B.R.1565(MODS)
Handbook for
TYPE 618
AND RECEIVER OUTFIT CAS
MODIFICATIONS

MAY 1971

MINISTRY OF DEFENCE
DIRECTOR GENERAL WEAPONS (NAVAL)
(RE1058/56)

TYPE G18 - TRANSMITTER H.F. AP.100333RE-SITING OF RESISTORS R67, R70 & R71

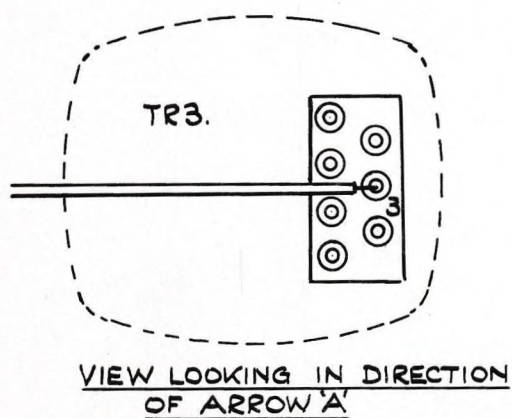
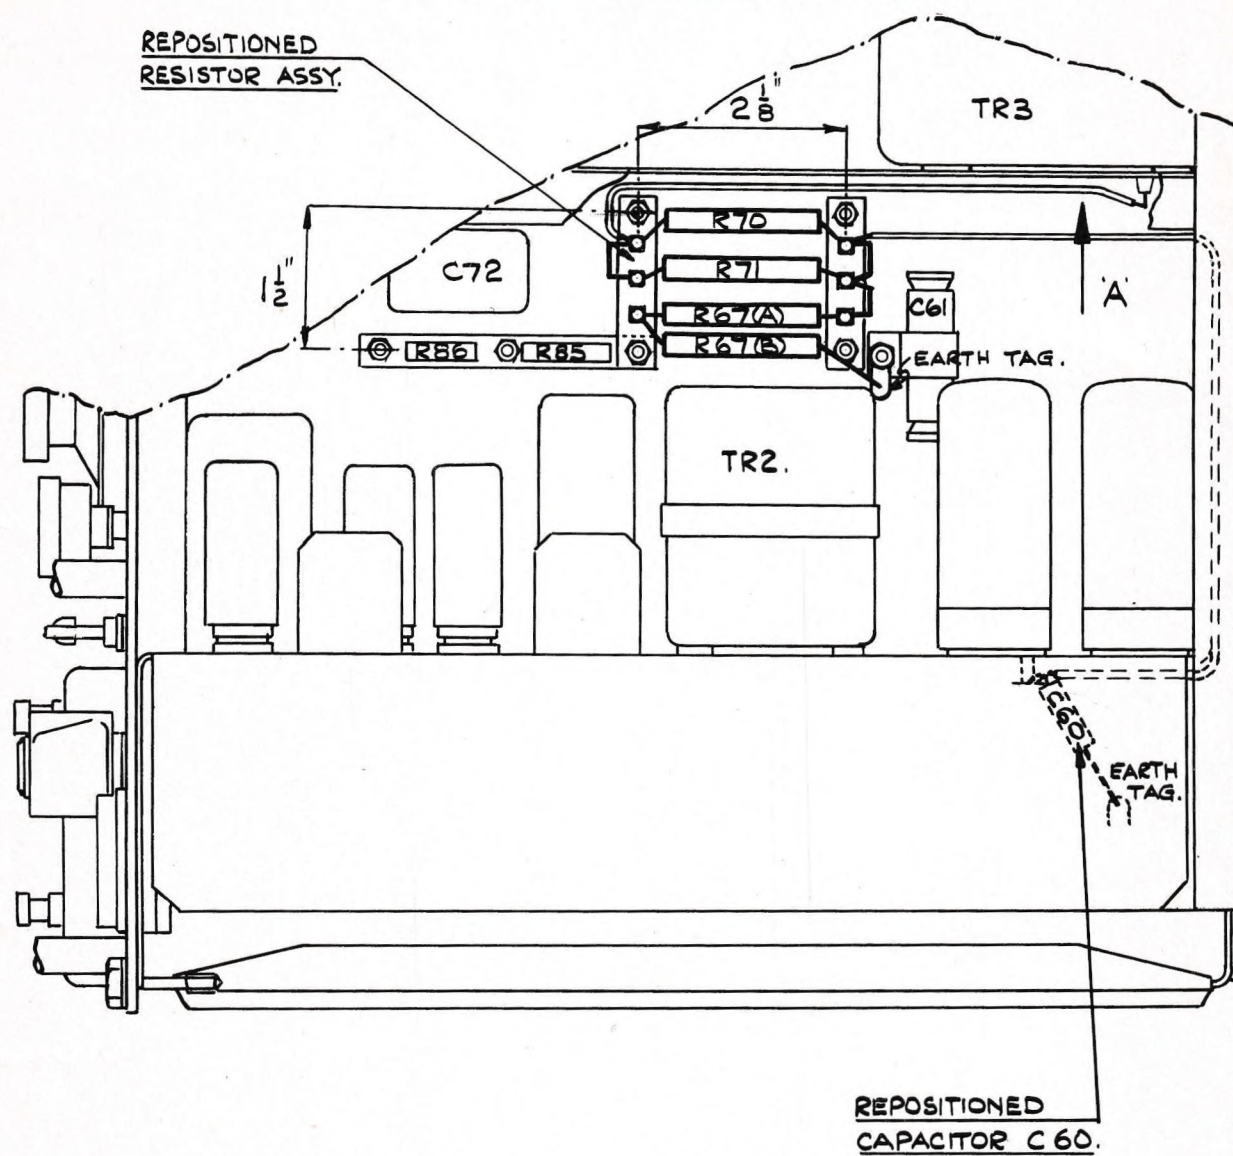
- (6) Remove the capacitor C60 from the assembly and connect it between the insulated pillar and the earth tag mentioned in 3 and 4 above.
- (7) Remove resistor R67 (15 k) and replace it by two pattern Z113418 or Z244086 resistors wired as shown on Fig. 1.

- (8) Locate the tag strip holding two carbon resistors R85, R86 which is in line with the top of the driver transformer (TR2) on the deck above.
- (9) Using the inner securing bolt of this tag strip for location drill three 4 B.A. clear holes as shown in Fig. 1 and fit the resistor assembly using the screws and spacers removed in (5) above.

- (10) Connect a lead of suitable p.v.c. wire between the common point of resistors R67A, R70 and R71 and the insulated pillar mentioned in (3).
- (11) Connect a lead from the common point of resistors R70 and R71 only to the terminal of the modulation transformer (TR3) which is common to capacitor C61.

- (12) Solder the free end of resistor R67B to the adjacent earth terminal.
- (13) Ensure the four resistors are widely spaced from each other and from transformer TR2 and return the transmitter to its case.

WIRING CHANGES

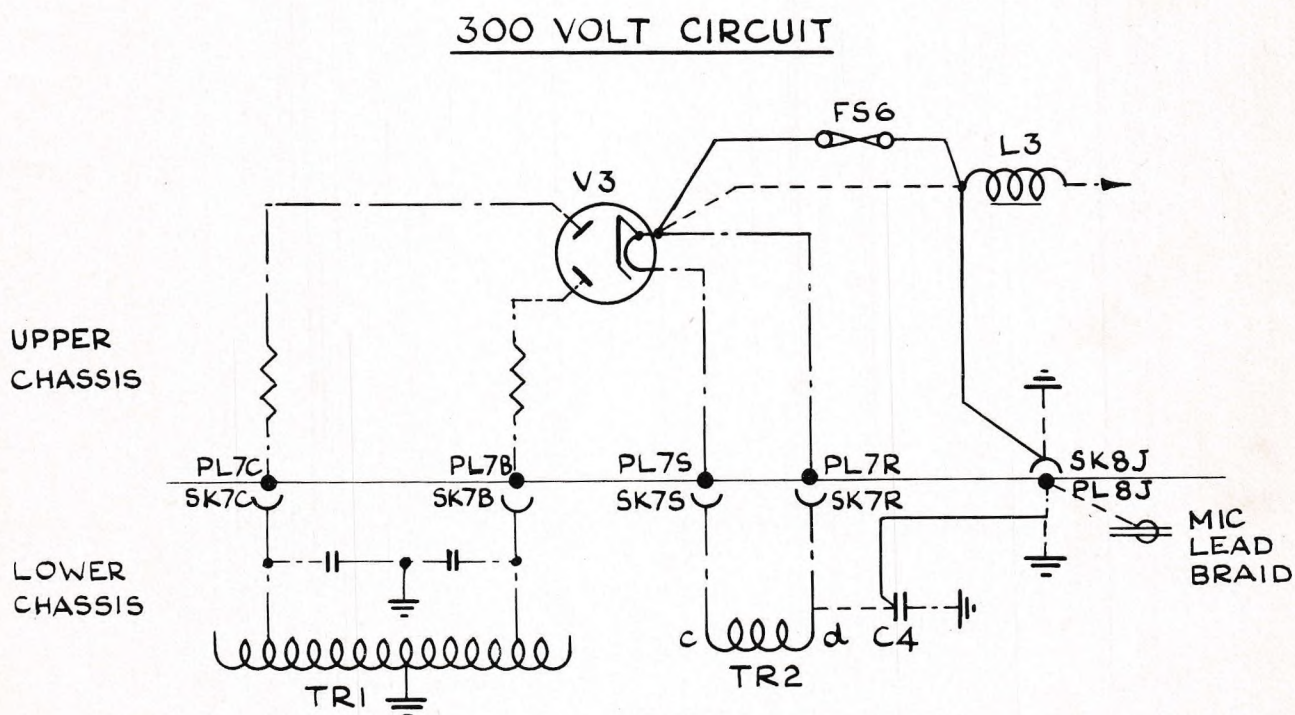
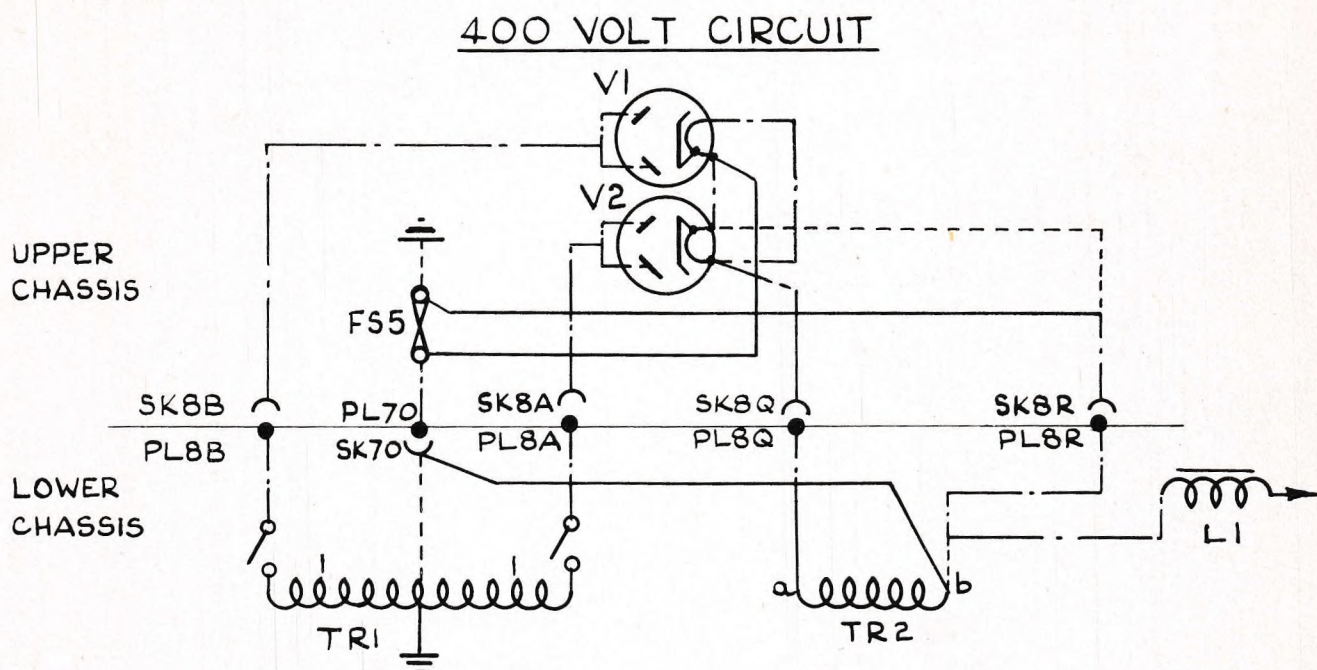
Refer to BR 1565 Figs. 20, 22, 23 and Fig. 1 attached.

- (a) Locate fuseholder FS5, disconnect the earth connection at both ends and discard.
- (b) Locate the connection running between socket SK8 pin R and V2 valve-base pin 8 (hk). Disconnect this lead at the valve-base, extend the lead by about one foot and sleeve or tape the joint. Run the lead through the adjacent grommet and connect it to the tag of FS5 from which the earth lead was removed in (1).

- (c) Run a new connection from V1 valve-base pin 8 (hk) through the grommet to the other tag of fuseholder FS5 (pins 8 of V1 and V2 are common). This point on the fuseholder is also connected to plug PL7 pin 0.

- (d) Remove the connection from socket SK8 pin J (connected to earth) and tape the end.
- (e) Run a new connection from socket SK8 pin J to the inner terminal of choke L3. Remove and discard the lead at present fitted between the inner terminal of choke L3 and V3 valve-base pin 8 (hk).

- (f) Run a new connection from the inner tag of choke L3 through the grommet and connect to the end connection of fuseholder FS6 (Spare).
- (g) Run a new connection from the side tag of FS6 through the grommet to V3 valve-base pin 8 (hk).

- (a) From the centre secondary tag of transformer TR1 disconnect the lead going to socket SK7 pin 0. Connect the centre tag of transformer TR1 to the earth tag adjacent to transformer TR2.
- (b) Refer to Fig. 23 and locate the TR2 secondary tag connected to L1. Remove the two leads from this tag, solder together and tape or sleeve the joint.

- (c) Shorten the SK7 pin 0 lead disconnected in (1) and connect it to the secondary tag from which the leads were removed in (2).
- (d) Locate the connection between plug PL8 pin J and the earth tag adjacent to the rubber grommet at the rear of the unit. Disconnect the lead at the earth tag.
- (e) Remove entirely the short connection between plug PL8 pin J and the braid of the twin microphone lead. Do not disturb the other connection on pin J. To carry out this operation it will be necessary to free the cable sleeve and outlet of the plug.
- (f) From the TR2 secondary tag marked SK7/R in Fig. 23 disconnect the lead which is connected to capacitor C4. Pull the lead out of the cable-form back to the capacitor.
- (g) Join together and sleeve the two leads left free by operations (4) and (5) i.e. Connect C4 to PL8 pin J.
- (h) The modified circuit should now be as shown in Fig. 2 attached.

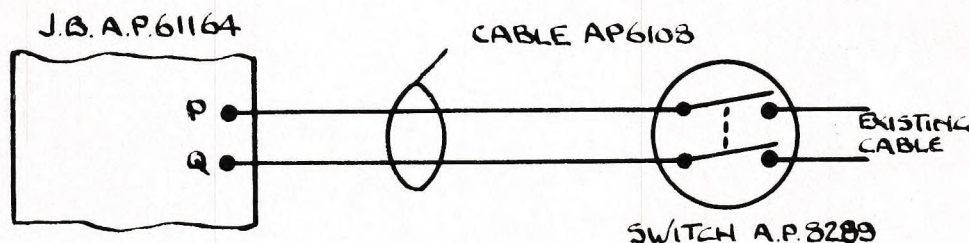
- (1) Open up the 32-way junction box A.P.61164 (normally fitted under the Operator's bench).
- (2) Remove the existing twin cable from terminals P and Q in the J.B. and re-wire to the new switch A.P.8289 as shown, the switch being fitted at a convenient position on the operating bench.

- (3) Refit cover to junction box.
- (4) Mark switch positions "RX OUTPUT NORMAL"
and "RX OUTPUT ISOLATED".

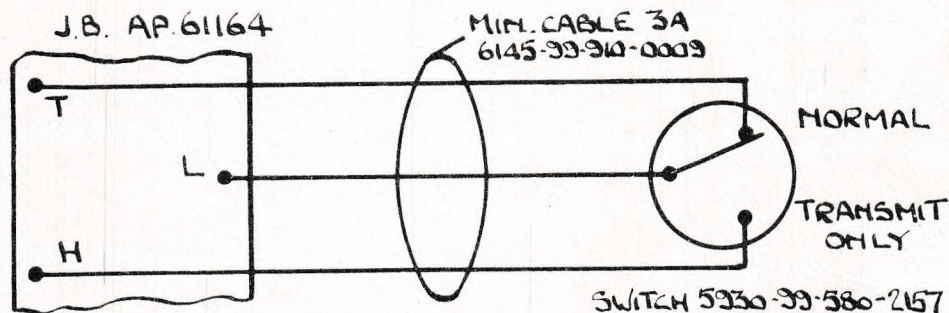
- (1) Open up the 32-way junction box A.P.61164 (normally fitted under the operator's bench).
- (2) Remove the wire linking terminals L and T.
- (3) Fit the new change-over switch 5930-99-580-2157 adjacent to the morse key on the bench and wire it to the J.B. A.P.61164 as follows:-

- (4) Refit cover to Junction Box.
- (5) Mark switch positions 'NORMAL' and 'TRANSMIT ONLY'.
